ADDENDUM NO. 2 TO PROJECT NO. 44496

**CONSTRUCTION WORK, HVAC WORK AND ELECTRICAL WORK
REPLACE UNDER GROUND HEAT AND WATER LINES
ULSTER CORRECTIONAL FACILITY
750 BERME ROAD
NAPANOCH, NY**

January 29, 2014

DWG NO:
H-102

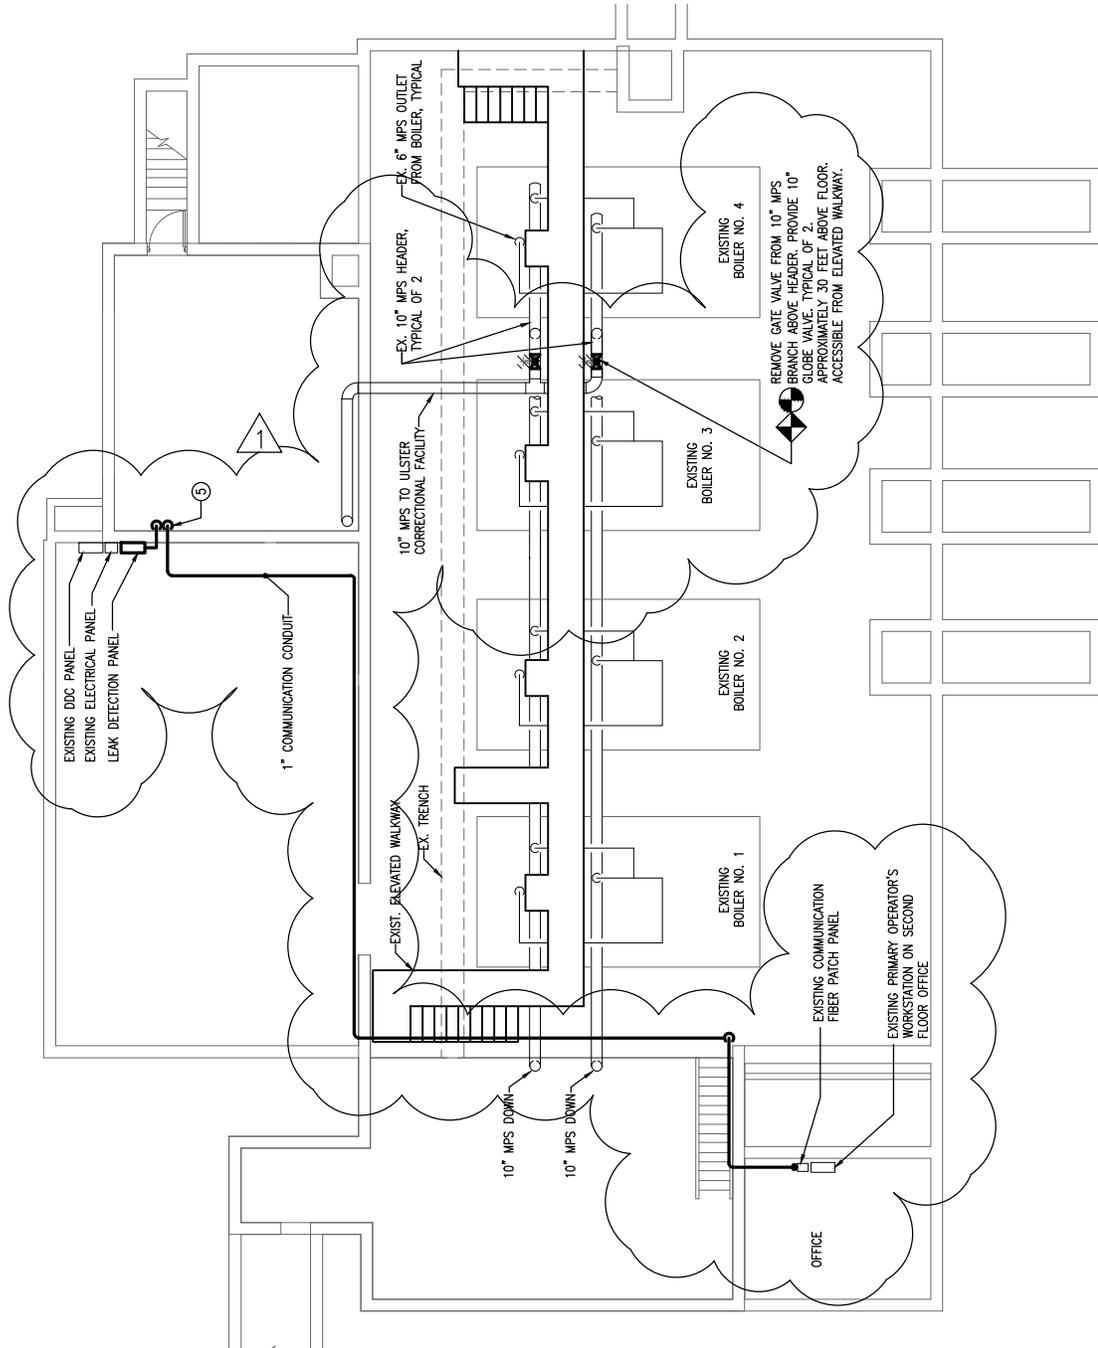
22. Drawing No. H-101: DETAIL 2: Delete this Detail in its entirety. Refer to Addendum Drawing No. H-102 dated 1/29/14 for Revised Detail.

SHEET TITLE: REVISION TO DETAIL 3,
BUILDING NO. 50
FIRST FLOOR PLAN

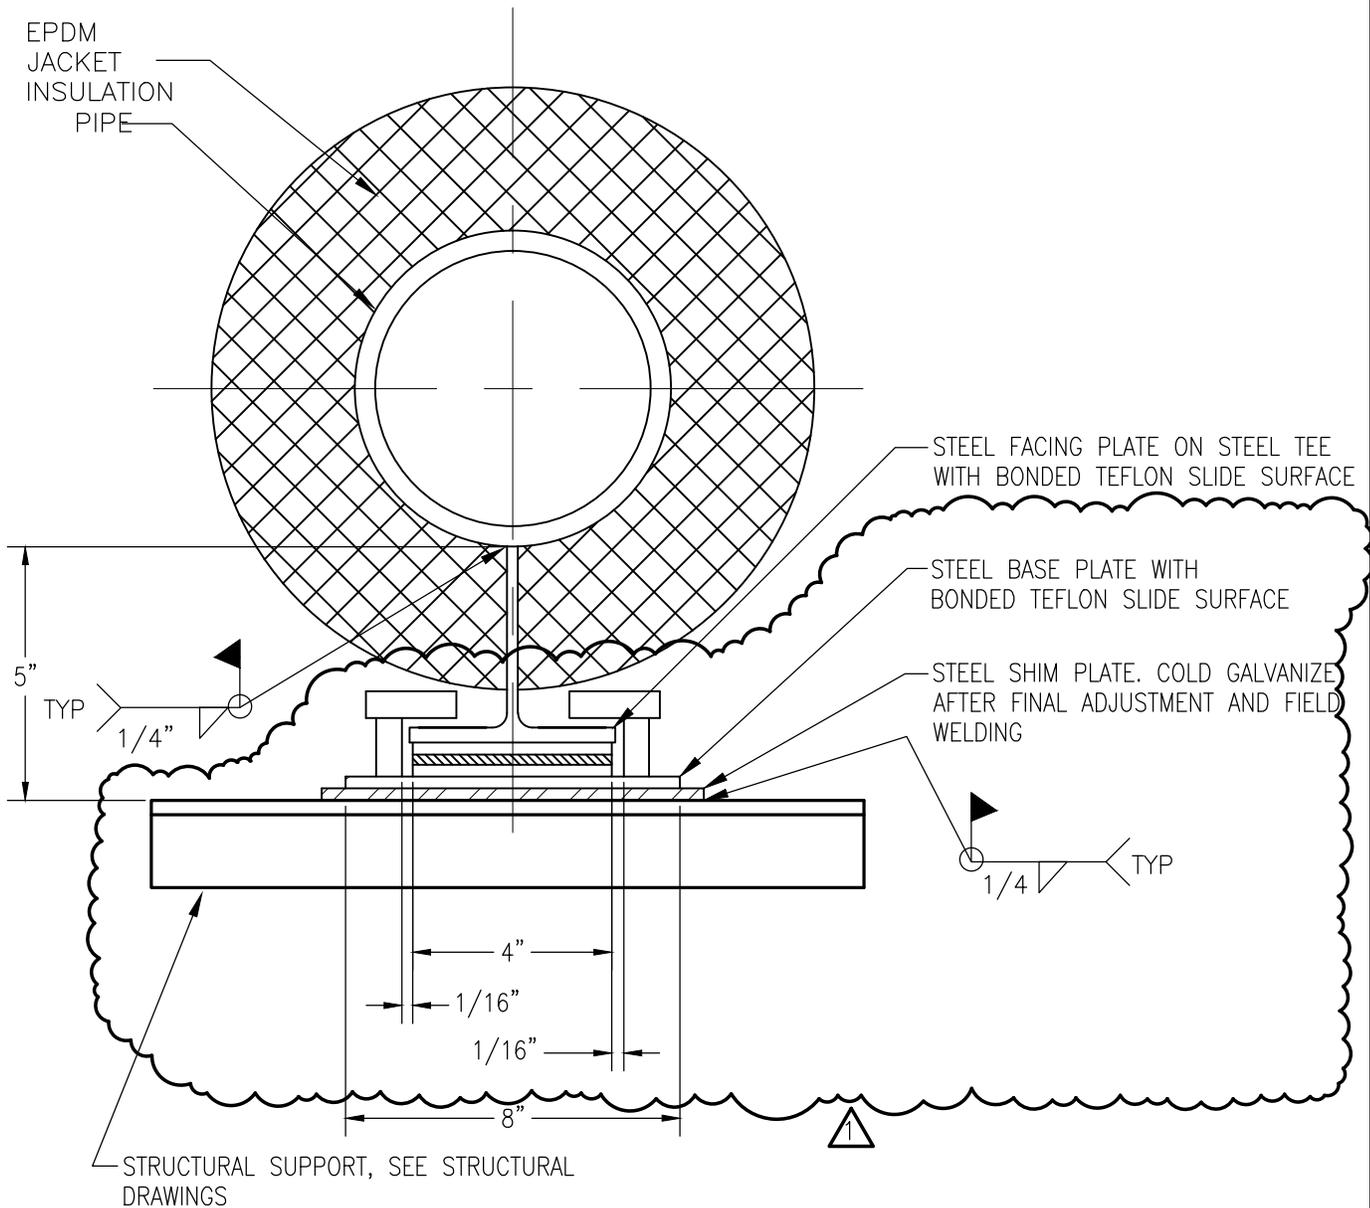
- 1. Drawing No. M-410, Detail 2, GENERAL NOTES: Add the following Note:
“2. 18’x6’ chain link fence surrounding mechanical equipment shall be 8 feet high.”
- 2. Drawing No. M-411, Detail 3: Delete this Detail in its entirety. Refer to Addendum Drawing No. M-412 dated 1/29/14 for Revised Detail.

SHEET TITLE: REVISION TO
DETAILS 5

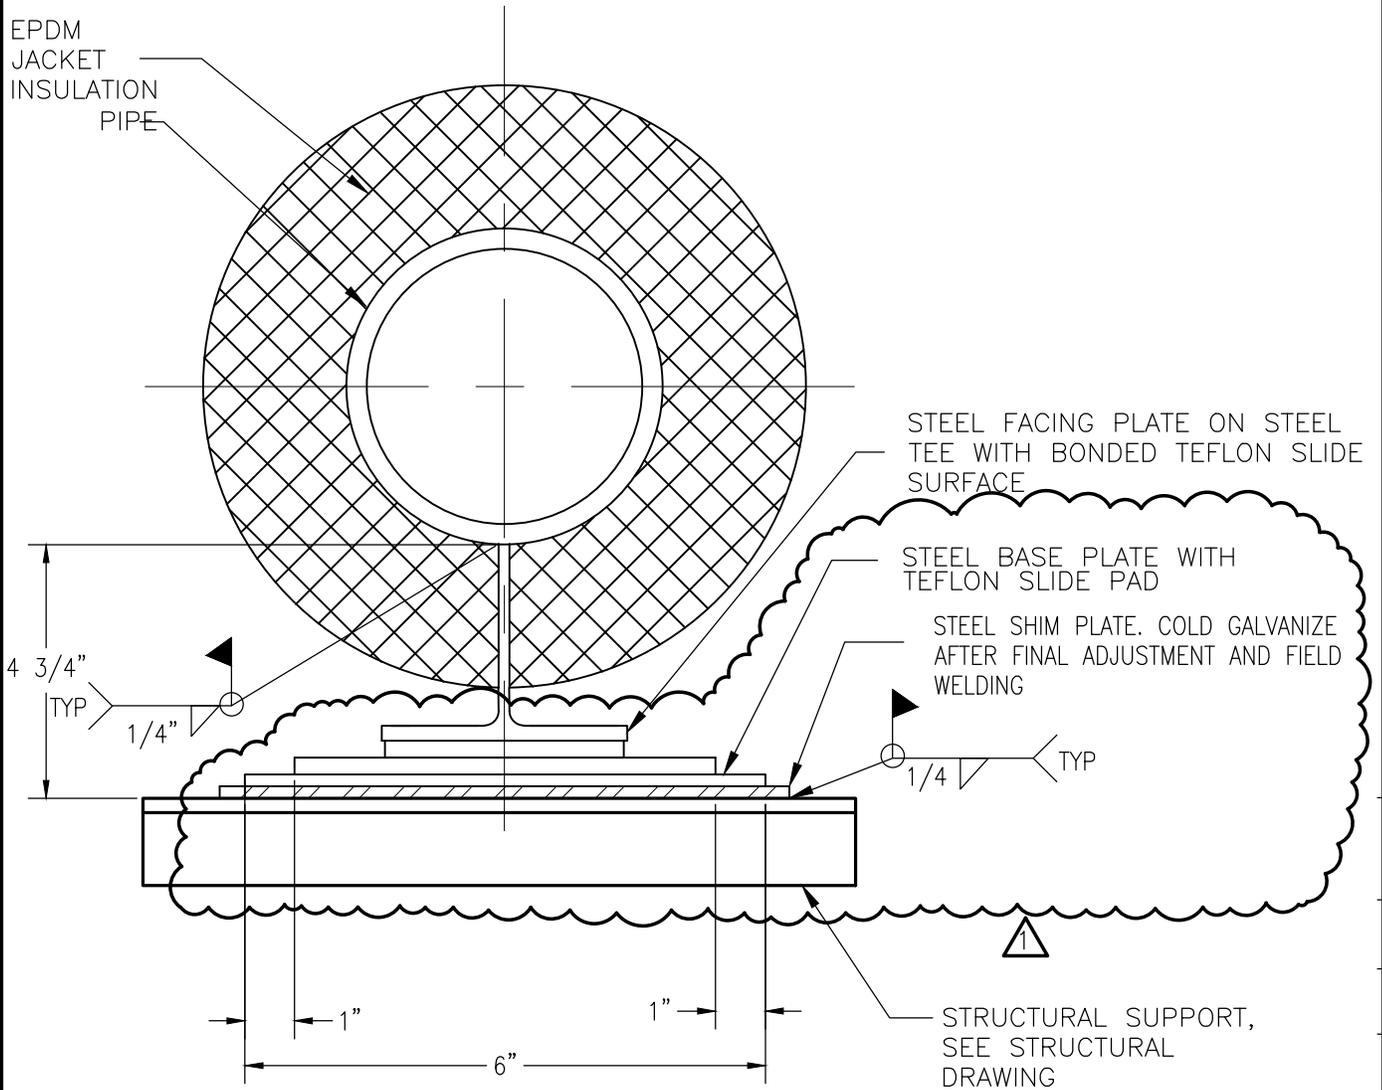
- a. Delete portion of DETAIL 1: Refer to Addendum Drawing No. M-507 dated 1/29/14 for Revised Detail.
- b. Delete portion of DETAIL 2: Refer to Addendum Drawing No. M-508 dated 1/29/14 for Revised Detail.

DWG NO: M-717

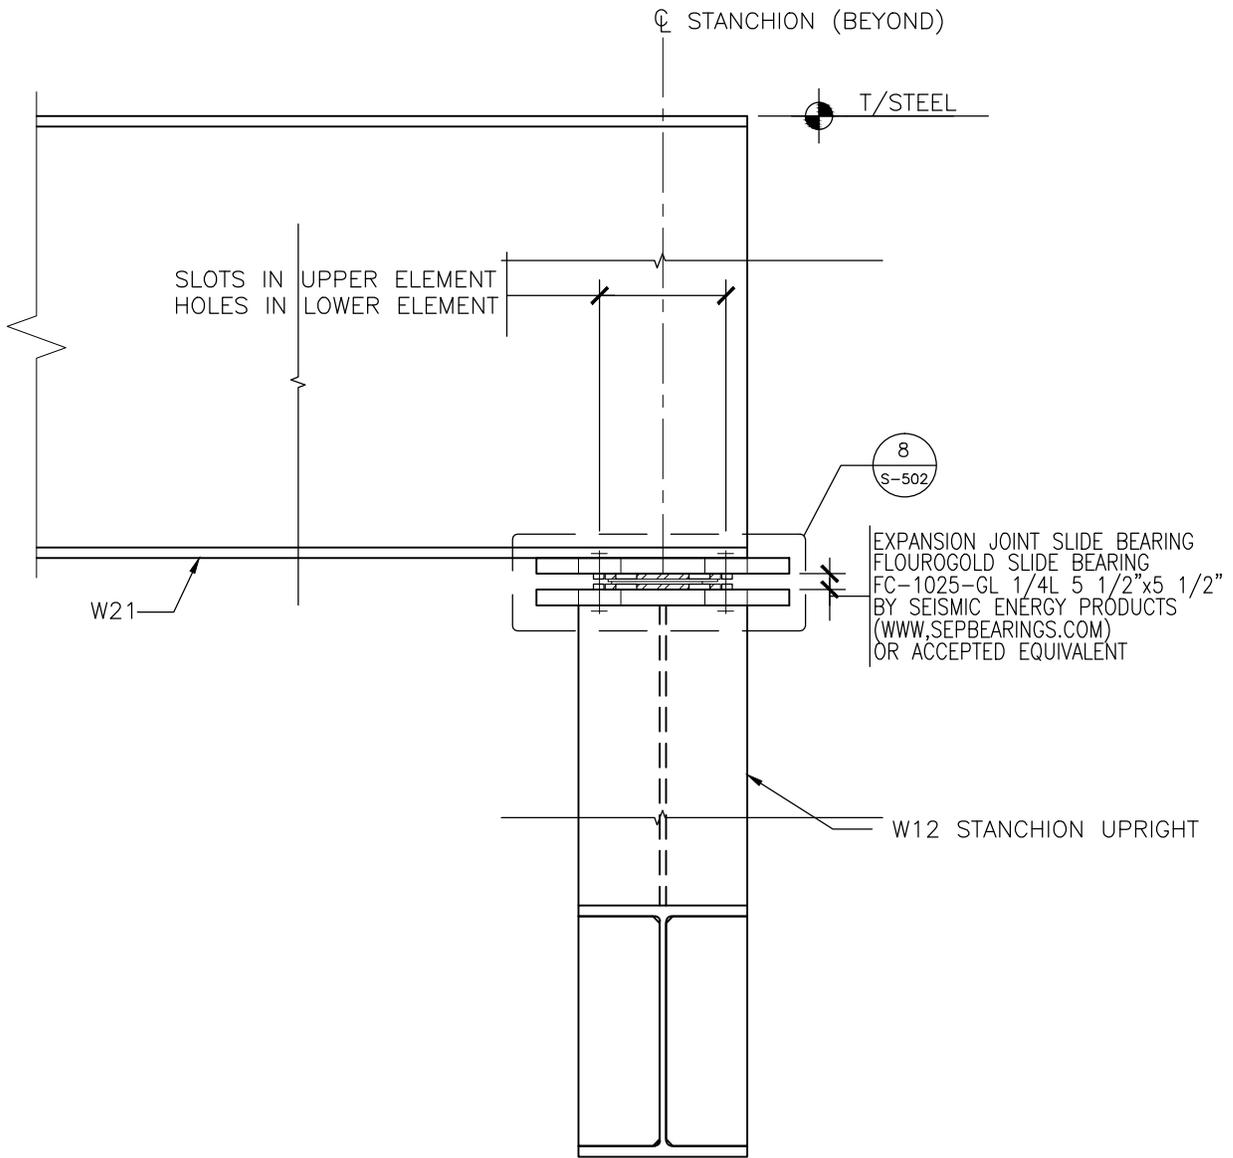
16. Drawing No. M-712, DETAIL 1: Delete this Detail in its entirety. Refer to Addendum Drawing No. M-717 dated 1/29/14 for Revised Detail.

DWG NO:
S-507

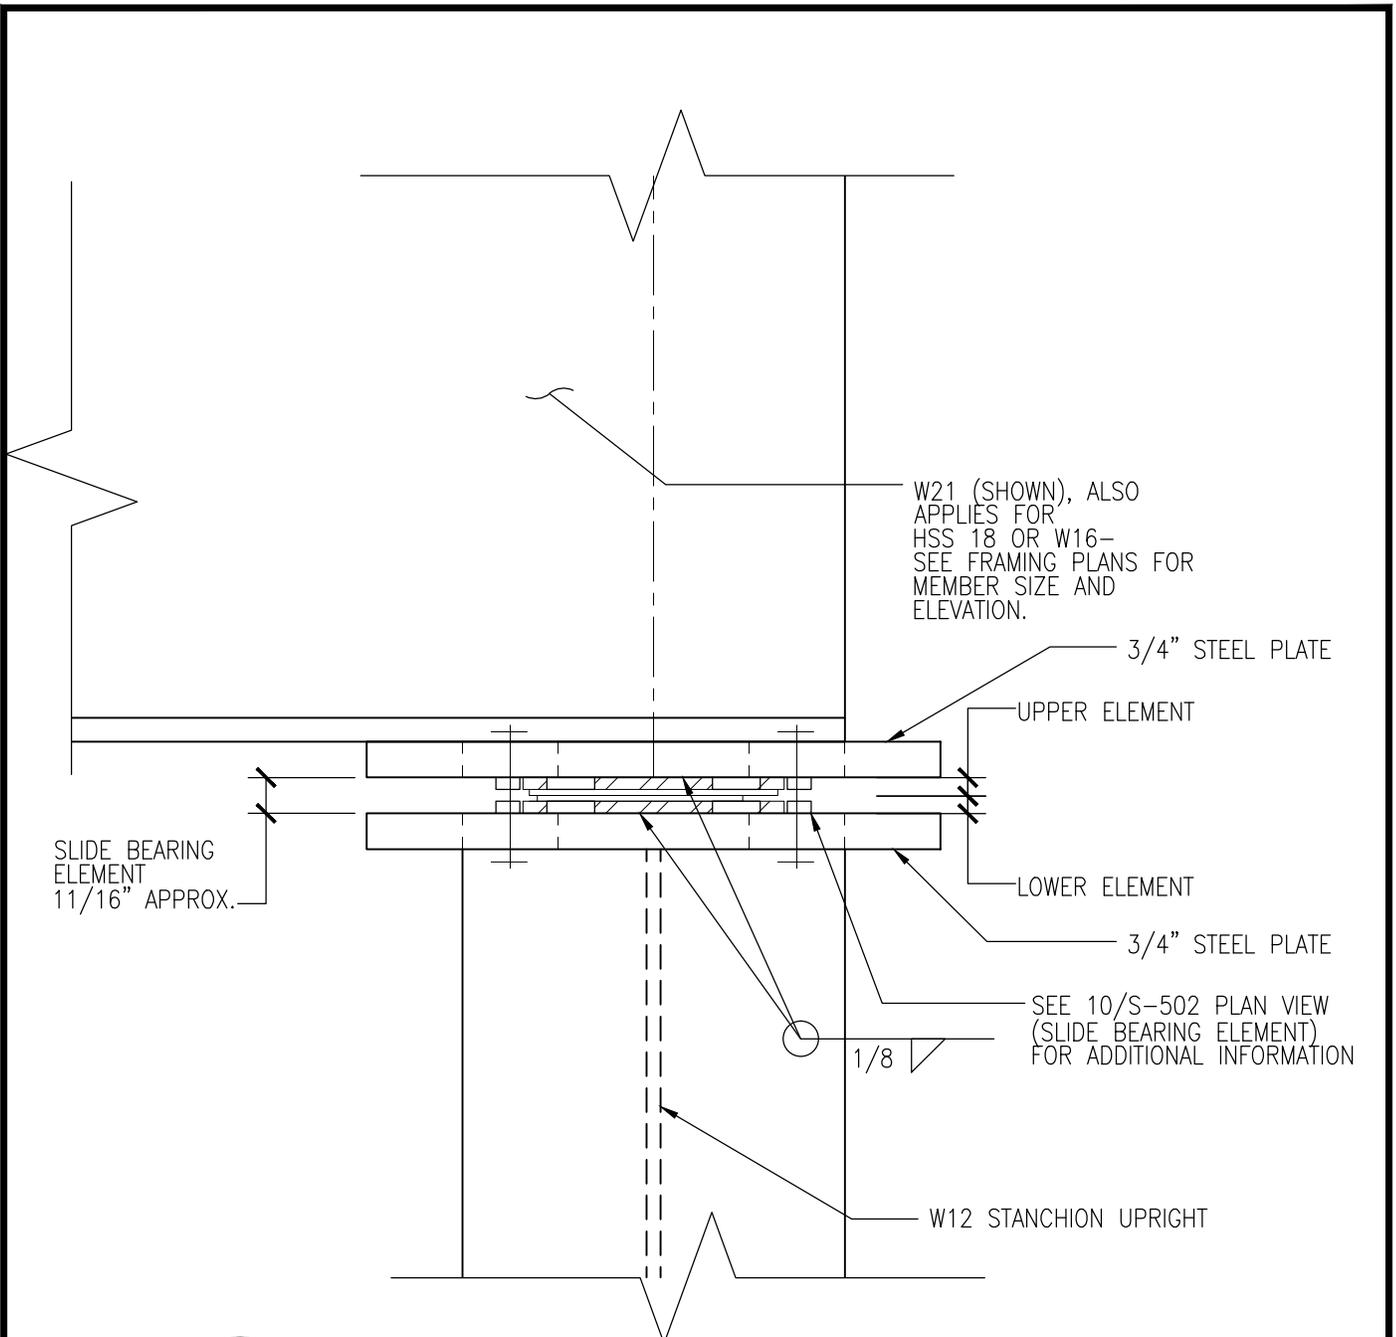
24. Drawing No. S-502, DETAILS:
 - a. DETAIL 7: Delete this Detail in its entirety. Refer to Addendum Drawing No. S-507 dated 1/29/14 for Revised Detail.

ADDENDUM NO.1	REFERENCE DRAWING: S-502
SHEET TITLE: REVISION TO TYPICAL DOUBLE BEAM FRAMING PLAN, SECTIONS AND DETAILS	
PROJECT: REPLACE UNDERGROUND HEAT & WATER LINES ULSTER CORRECTIONAL FACILITY

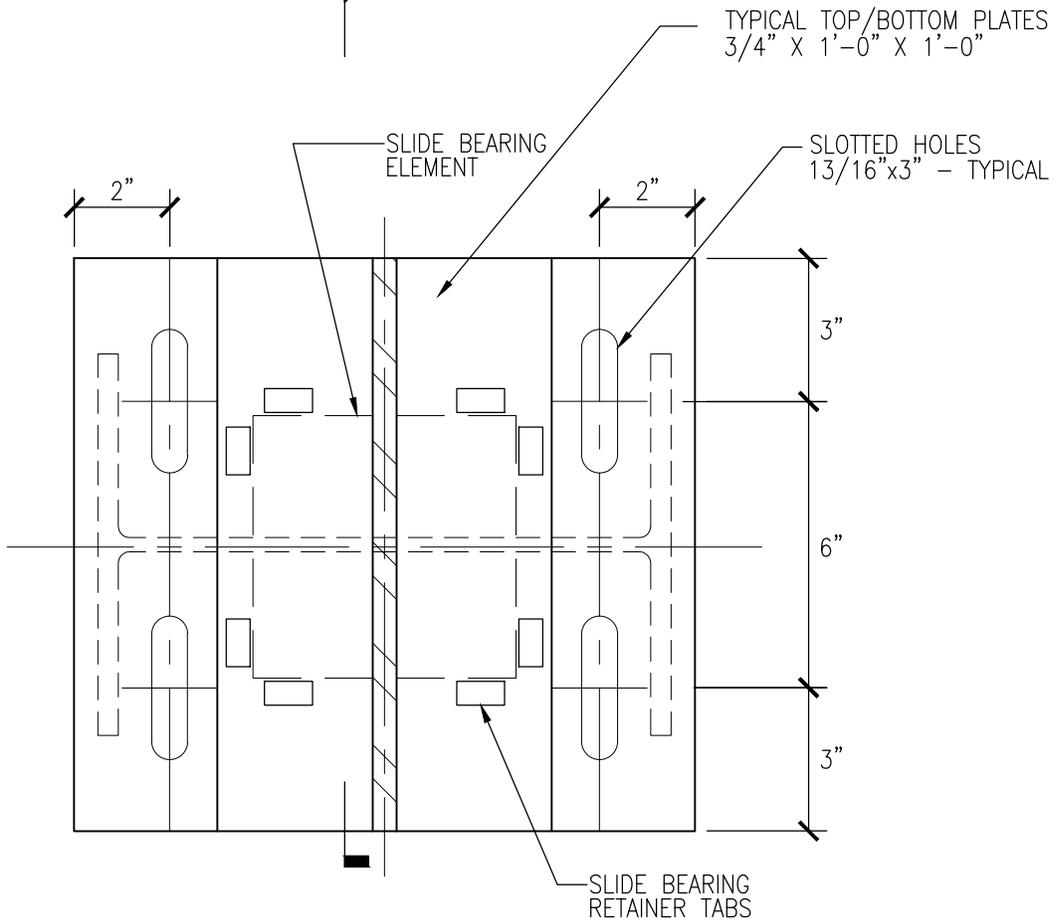
- b. DETAIL 8: Delete this Detail in its entirety. Refer to Addendum Drawing No. S-508 dated 1/29/14 for Revised Detail.
 - c. DETAIL 10: Refer to Addendum Drawing No. S-509 dated 1/29/14 for Revised Detail.

DWG NO:
S-510

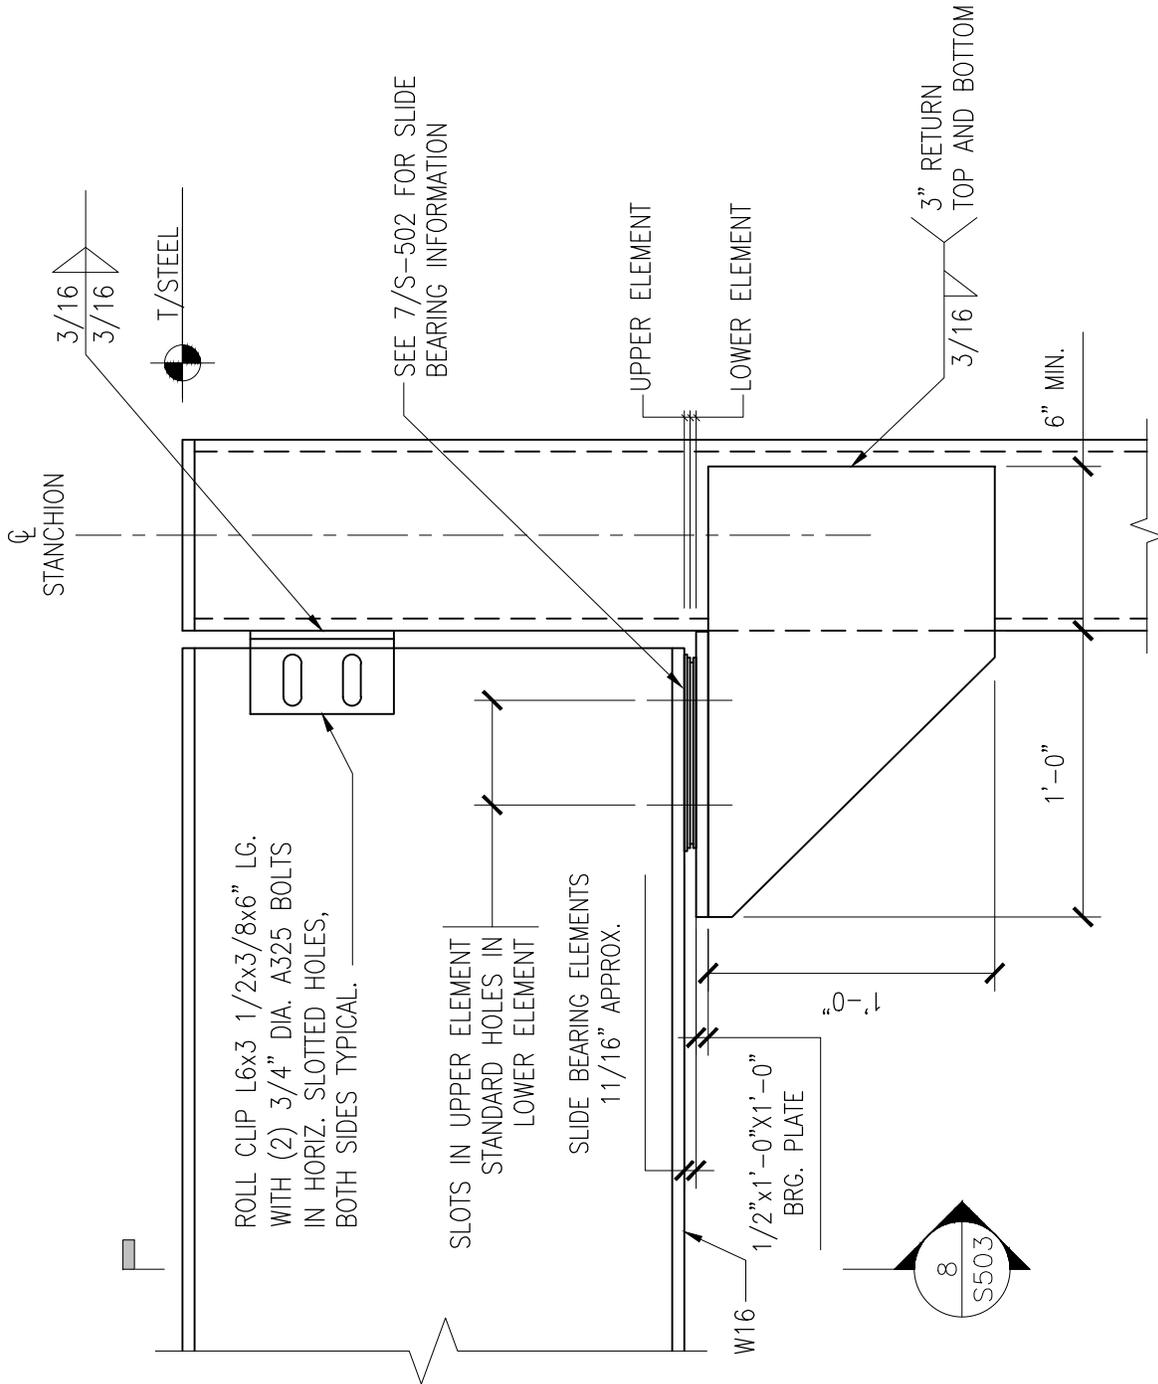
- d. DETAIL 11: Refer to Addendum Drawing No. S-510 dated 1/29/14 for Revised Detail.
25. Drawing No. S-503, DETAILS:
 - a. DETAIL 6: Delete this Detail in its entirety. Refer to Addendum Drawing No. S-511 dated 1/29/14 for Revised Detail.
